# SITE PLAN REVIEW AND APPEARANCE BOARD

### ---STAFF REPORT---

**ITEM:** **50 SE 4<sup>th</sup> Avenue (2017-112)** - Class V Site Plan, Landscape Plan with waiver request, and Architectural Elevations to demolish an existing one-story office building and construct a 3,396 sq. ft. two-story building with restaurant uses in the first story and open air rooftop dining.

LANDSCAPE PLAN

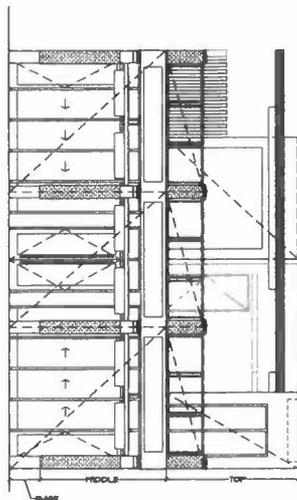
A Landscape Plan is included with the Class V application with a waiver request related to landscape requirements in the rear parking area. Required streetscape trees have already been provided within the right-of-way in front of this parcel; however, three cabbage palms are proposed to be added to the planter. Most of the landscape improvements are provided in the rear of the building. An 18-ft. tall Gumbo Limbo and 16-ft. tall Alexander Palms are the larger species proposed, with Silver Buttonwood and Dwarf Holly shrubs. The roof of the first story will largely be used for an outdoor dining and bar area. A 645 square foot area is separated from the customer area for raised planter beds for growing vegetables and herbs. This type of landscaping is not required, but is encouraged. Details regarding irrigation, etc. are not included for the planting beds at this time.

The waiver request is to LDR Section 4.6.16(H)(3)(d), which requires a landscape barrier of at least five feet between vehicular use area and the abutting property line. A barrier of 2'-1" is proposed. The area is proposed to be planted with Silver Buttonwood, 16-ft. tall Alexander Palms, and a Simpson Stopper.

1. The location and number of bicycle racks illustrated on Sheet L-1 is updated to be consistent with the Site Plan;
2. The tabular data on the Photometric Plan is updated to reflect the number of fixtures and lighting levels shown on the Proposed Lighting Plan; and
3. The word “obscure” is replaced with the word “block” on SP1.

WEST ELEVATION  
3/16" = 1'-0"

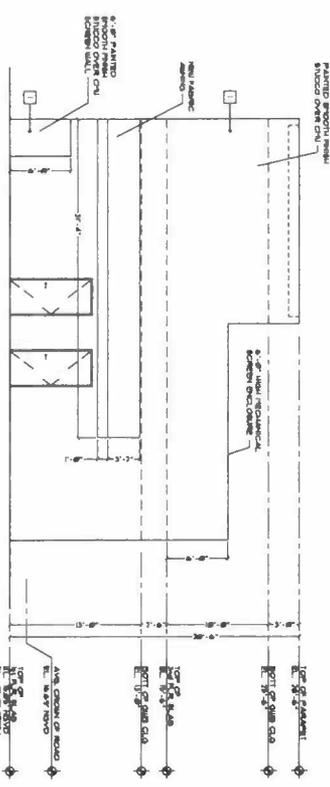
The West Elevation faces the rear, with parking, the can wash and refuse area. Currently, no windows are proposed, which would allow restaurant workers to survey the area prior to opening the door. **Staff recommends specifying doors that have windows or adding a window to the rear elevation to provide oversight of the rear area; this is attached as a condition of approval.**

1. The arcade columns will have a traditional base and capital, with the brick veneer applied to the full column shaft; and
2. The West Elevation will incorporate windows on the doors or wall to ensure restaurant staff can view the rear area prior to exiting the building.   
*and Stairwell*

**EAST ELEVATION**  
3/16" = 1'-0"

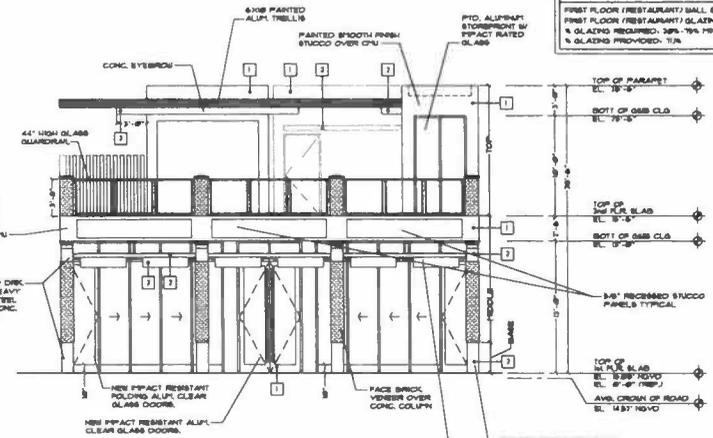
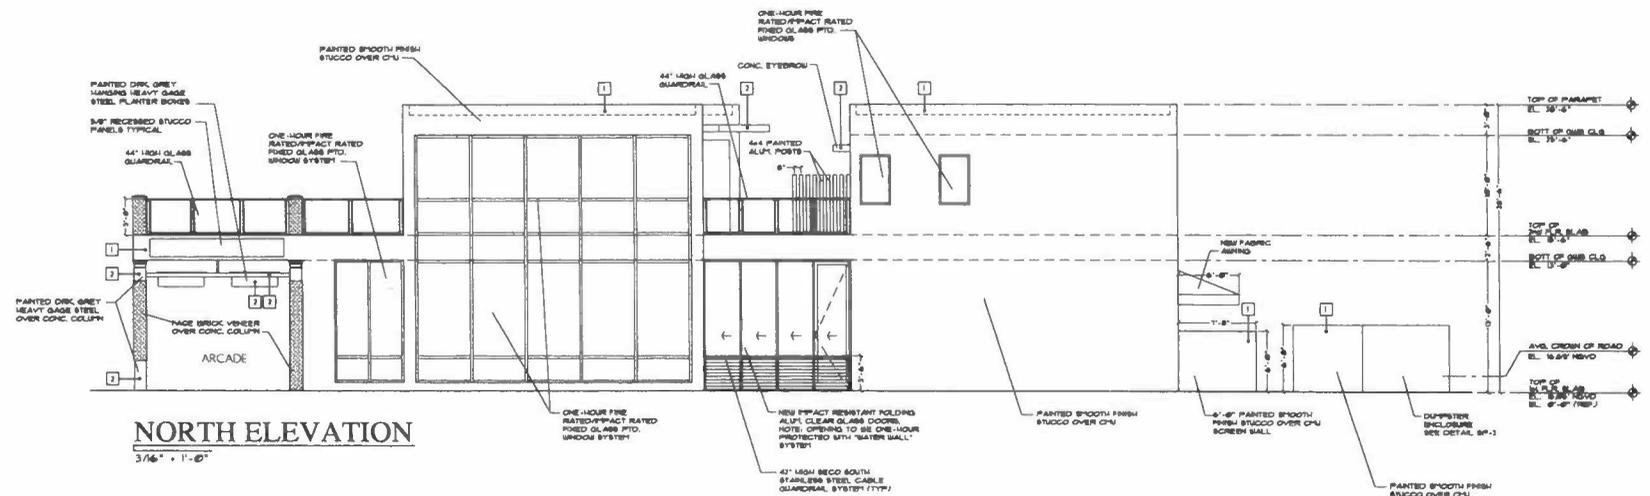
The arcade columns propose a capital that is traditional in its detailing, yet the brick veneer of the column is not consistent with grey painted steel proposed at the top and the bottom of the columns. No column base is proposed. This detailing is inconsistent with the traditional detailing common to the style; the brick material appears to be missing. **Staff recommends detailing the arcade columns with a traditional base consistent with the proposed capital and the brick veneer be applied to the whole column; this is attached as a condition of approval.**
